Gahcho Kue Information Requests

Yellowknives Dene First Nation

Table of Contents

Pictured: Extent of the 90m Landsat Vegetation Classification.

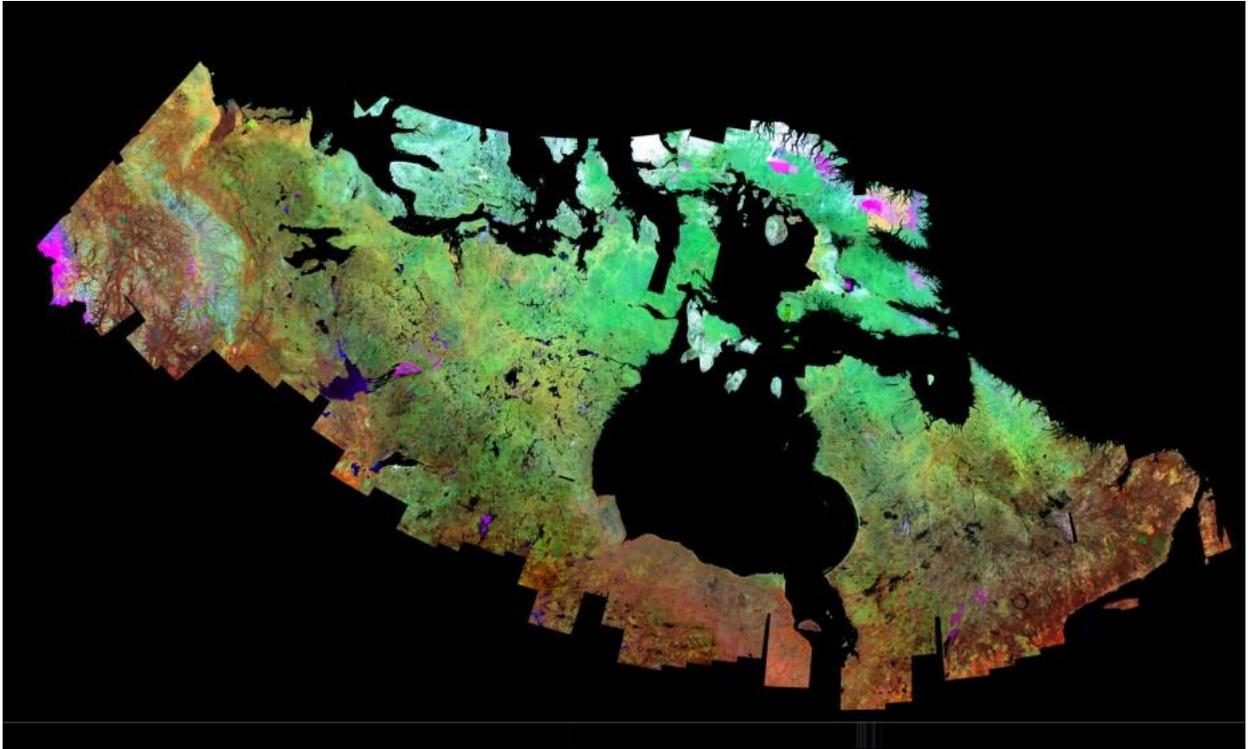
The proponent utilizes the Land Cover of Canada vegetation classification which has a 1 km resolution (pgs 7-83, 7-102) – the City of Yellowknife would be reduced to a few pixels, while Dettah is probably not detectable. This is a very low resolution basedata, which was then subjected to a modification process to resample it to a smaller resolution (down to 25-m resolution, then resampled to 200-m cell sizes (pg 7-83, 7-102). However, this does not improve the data, it simply slices the larger squares into smaller squares of the same value. Utilizing this data is only appropriate if the larger cells do a good job at approximating the actual landcover on the ground.

There are several high resolution datasets available for parts of the territory and from industrial projects in this extent. The creation of a unified legend/classification scheme would allow a comparison between the areas classified in the Land Cover of Canada and the higher resolution datasets, providing some indicator of the relative quality and confidence that the parties should have in the basedata. YKDFN have a real concern that the basedata used to complete the various analyses in the EIS may be producing results that will result in poor decisions and management as well as not assuring the Board or the Parties that the conclusions of no significant impacts are likely.

- 1) The proponent should undertake a comparison between the Land Cover of Canada dataset and the higher resolution data available from around the NWT and Nunavut to ensure that the information being utilized in the models is valid for the purpose. Example datasets include vegetation classifications from Tyhee, Avalon, Ekati, Diavik, and Bathurst Port and Road as a start.
- 2) The proponent should provide a discussion why they chose not to use the 90 m (Extents found below) medium resolution Landcover of Canada (2005) or the 250m MODIS Landcover of Canada (2005) rather than a 1km version. These datasets would have provided a much improved picture of caribou use.
